Attachment 1
Draft EIR Comment Letters

Re: Downtown West Mixed Use Plan (Google Project) - Draft Environmental Impact Report (DEIR)

RE: Downtown West Mixed-Use Plan (Google Project)
File Nos: GP19-009; PDC19-038; PD19-029
Review of Draft Environmental Impact Report

Subject: San Francisco Bay Regional Water Quality Control Board Comments on the *Downtown West Mixed-Use Plan (DWMUP) Draft Environmental Impact Report* (File Nos.: GP19-009, PDC19-039, and PD19-029), *City of San Jose, Santa Clara County*
SCH No. 2019080493

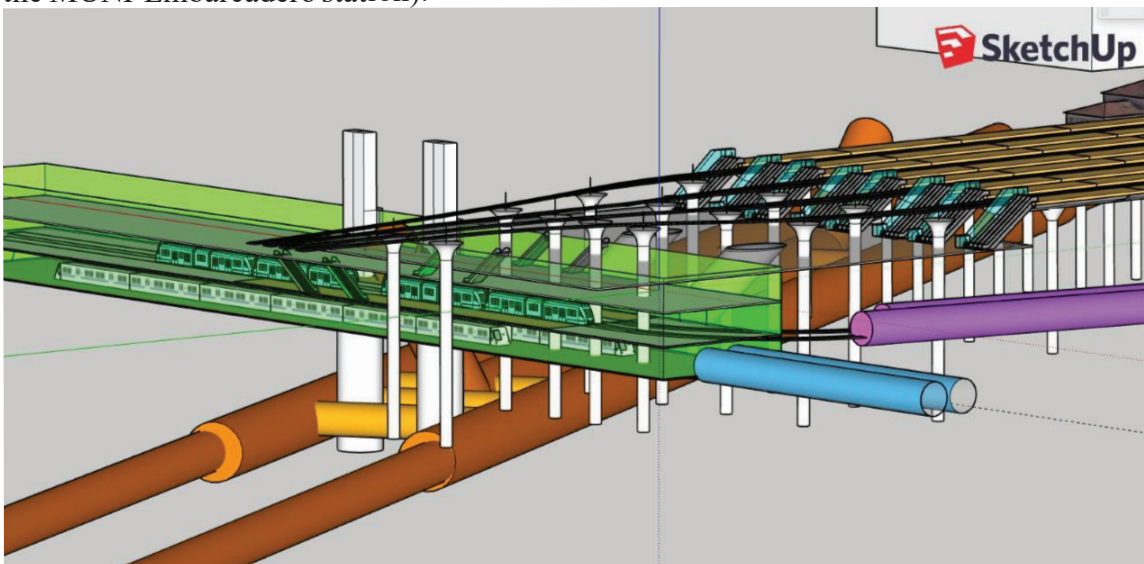
- Santa Clara (public transportation)
- Paseo de San Fernando (active transportation)
- Park (private transportation)

Construction phasing will start with the relocation of the light rail tracks to a tunnel (purple) between Sunol and White Street to the light rail (yellow) platforms located between the concourse and the BART (green) platforms (this configuration is similar to the MUNI Embarcadero station).

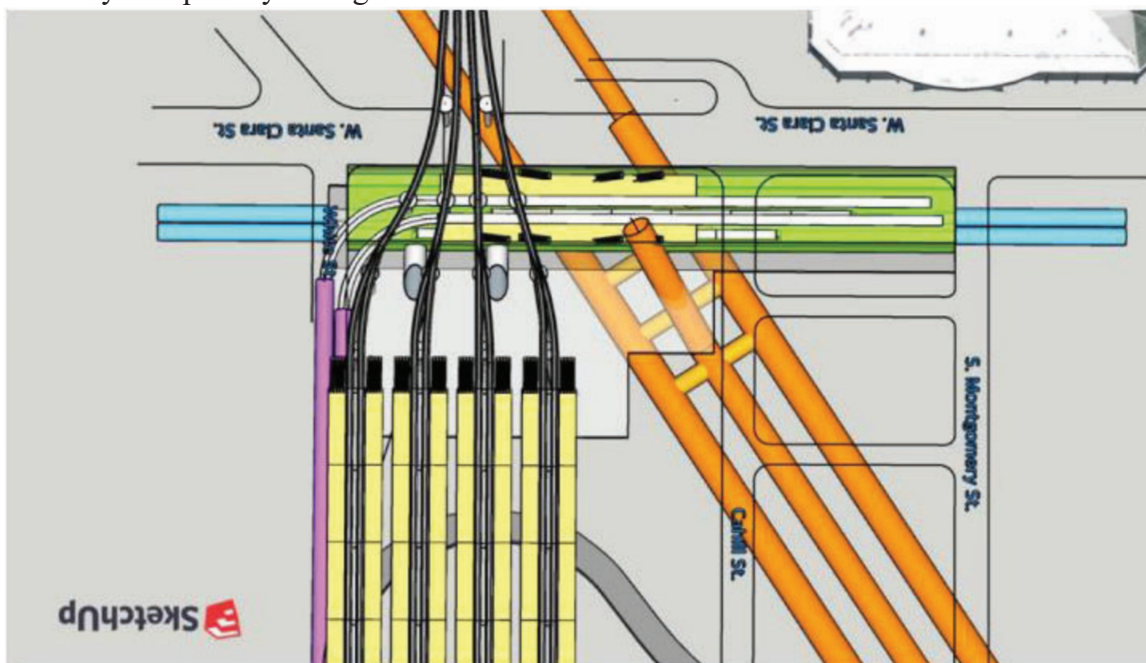
Next, the two west-most heavy rail tracks and platforms will be raised above the area currently occupied by the light rail station and tracks.

Please note that the extended heavy rail platforms will be centered between Park and West Santa Clara to eliminate conflicts with Parcels A, B & C. Additionally, the number of elevated station tracks will be reduced from 10 (or 11 as currently proposed) to 8 to eliminate throat expansion(s) beyond the existing right of way.

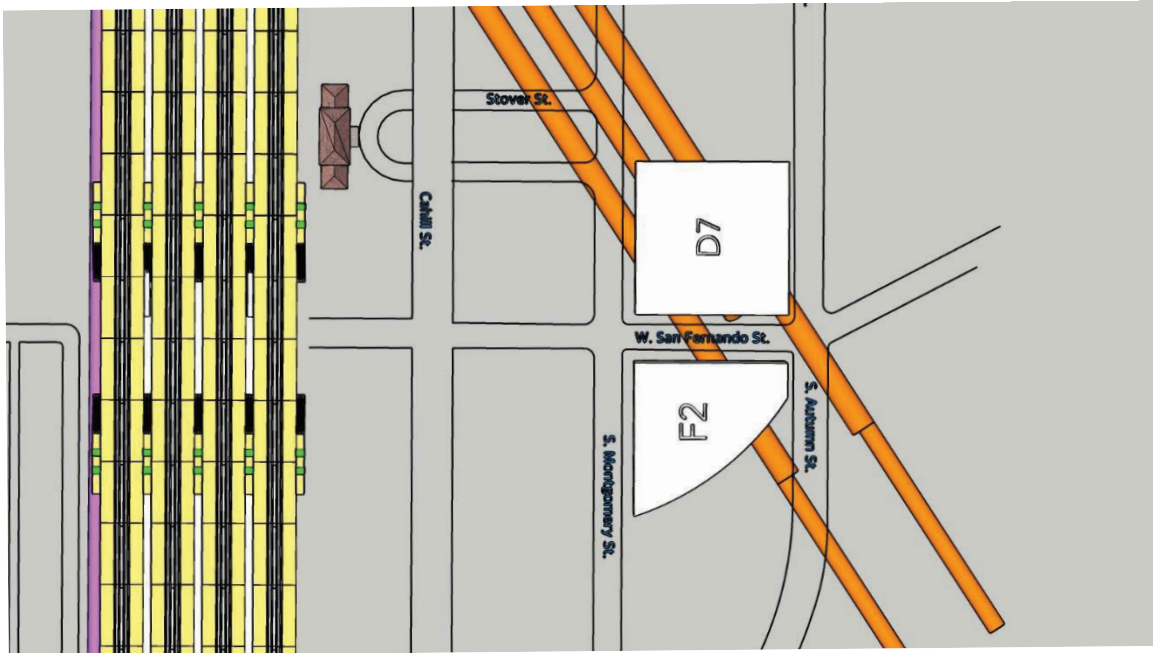
The 9th and 10th tracks will be located underground, one on each side of the future Airport connector concourse (orange). This concourse will connect to the West Santa Clara BART/LRT concourse (above) and a southern entrance at the West San Fernando/Autumn intersection (within building F2 and/or D7).

Figure 8a

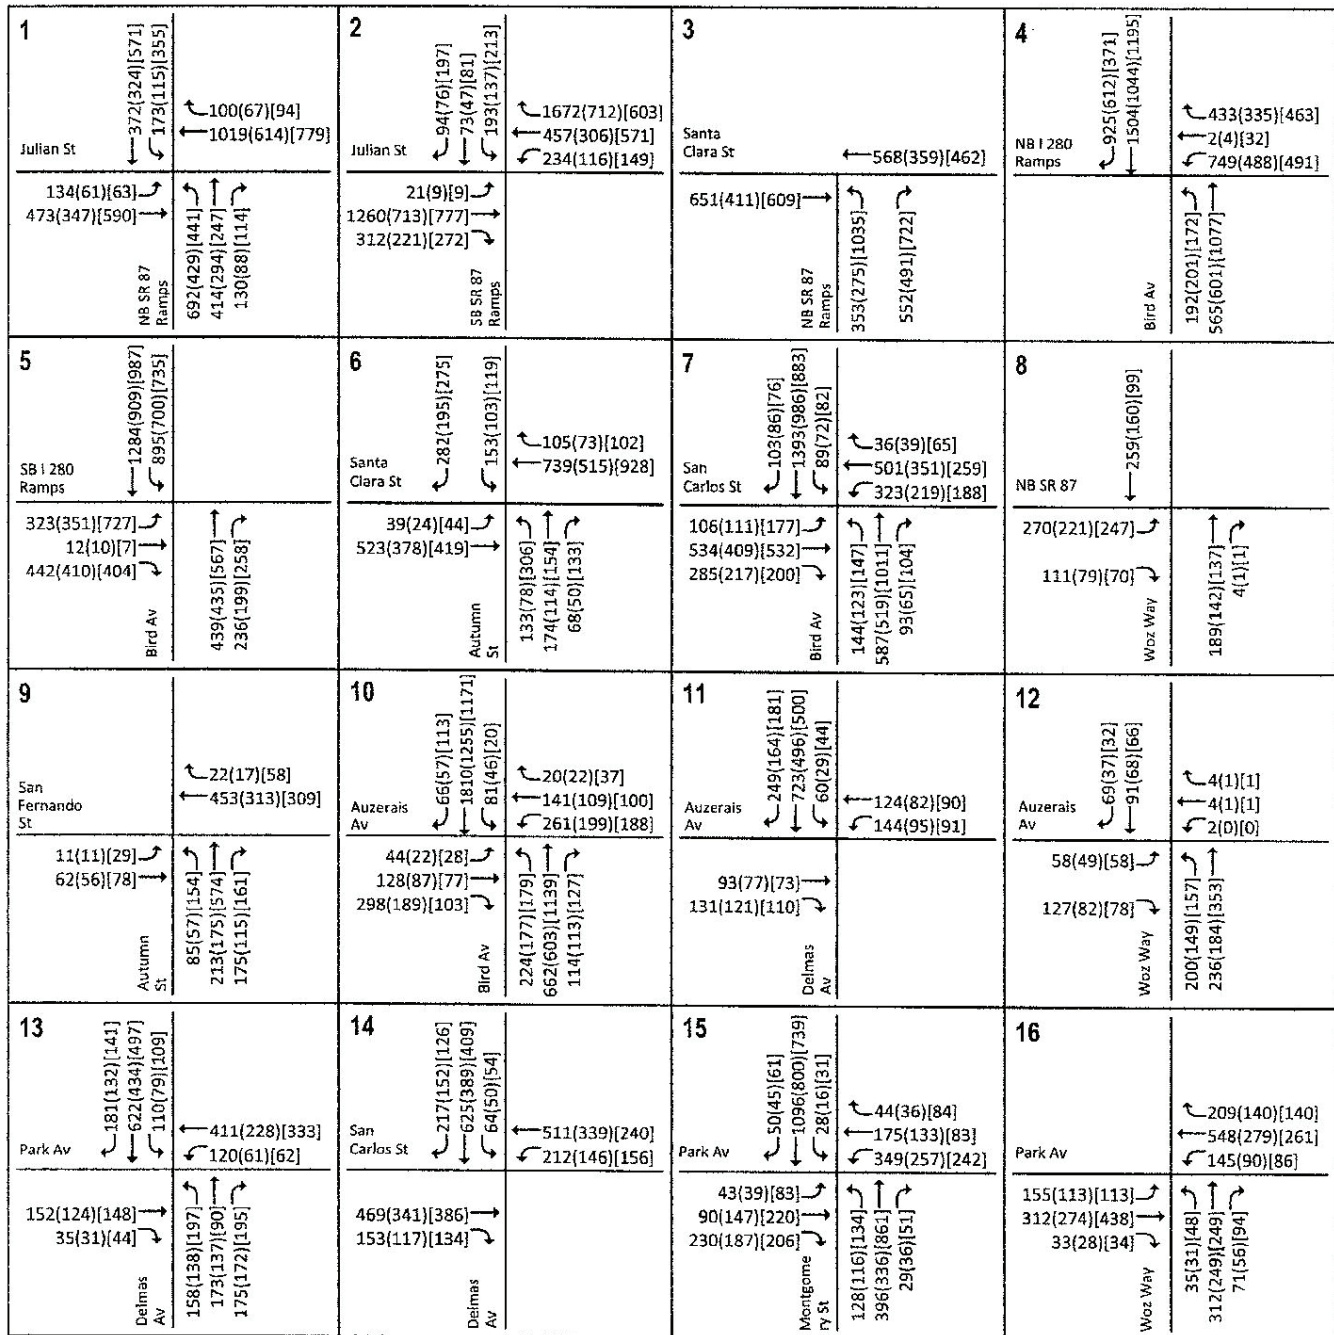
Several sections in this Memo refer to traffic volumes for SAP Center motorists and total traffic volumes. The source for these volumes is Figure 8a, Background Traffic Volumes, San Jose Ballpark Supplemental EIR, produced by Hexagon Transportation Consultants, Inc. (This Figure is attached as **Exhibit B.**)
